Access Compliance Report Public Rights-of-Way (Curb Ramps)

Main Street: **MERCANTILE_WAY** Cross Street: **THIRD_RD** Location: **W**

ADA ID: **RPRK211027171940** Ramp Type: **Type 4 - Parallel** Initial Pass/Fail: **Fail** Overall Compliance: **No** Severity Score: **2**

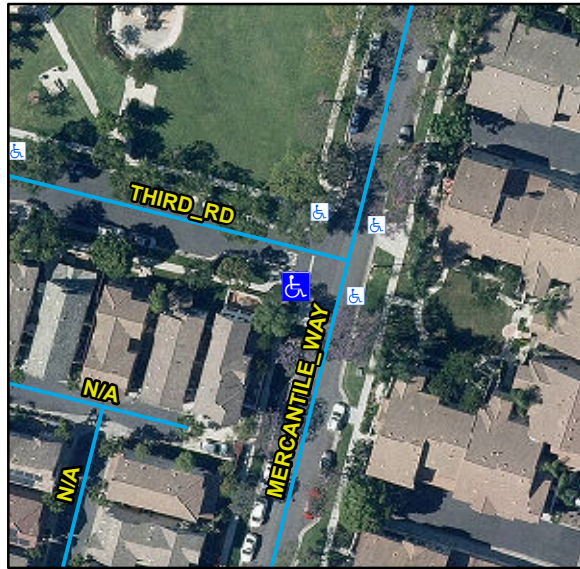
Compliance	Description	Data	Compliance	Description	Data
N/A	Ramp Length LT (in)	110	N/A	Ramp Length RT (in)	112
Yes	Ramp Width LT (in)	89	Yes	Ramp Width RT (in)	89
Yes	Ramp Run Slope LT (%)	3	Yes	Ramp Run Slope RT (%)	7.2
No	Ramp Cross Slope LT (%)	2.5	Yes	Ramp Cross Slope RT (%)	1.8
N/A	Landing Present	N/A	N/A	DWS Provided	N/A
N/A	Landing Length (in)	N/A	N/A	DWS Contrast	N/A
N/A	Landing Width (in)	N/A	N/A	DWS Length (in)	N/A
N/A	Landing Run Slope (%)	N/A	N/A	DWS Full Width	N/A
N/A	Landing Cross Slope (%)	N/A		DWS Offset Type	N/A
N/A	Landing Movement Obstructed?	N/A	N/A	DWS Offset Left (in)	N/A
	Landing Movement Type	N/A	N/A	DWS Offset Right (in)	N/A
N/A	Landing Shared	N/A			
N/A	Clear Space	Yes			
N/A	Clear Space To Crosswalk (in)	N/A			
N/A	Marked Crosswalk 1	No	N/A	Marked Crosswalk 2	No
	Crossing 1 Direction	SE		Crossing 2 Direction	NE
	Marked Crosswalk 1 Width (in)	N/A		Marked Crosswalk 2 Width (in)	N/A

Remove & Replace Curb Ramp With Two New Directional Ramps or Equivalent.

R304.5.3, STD 1115
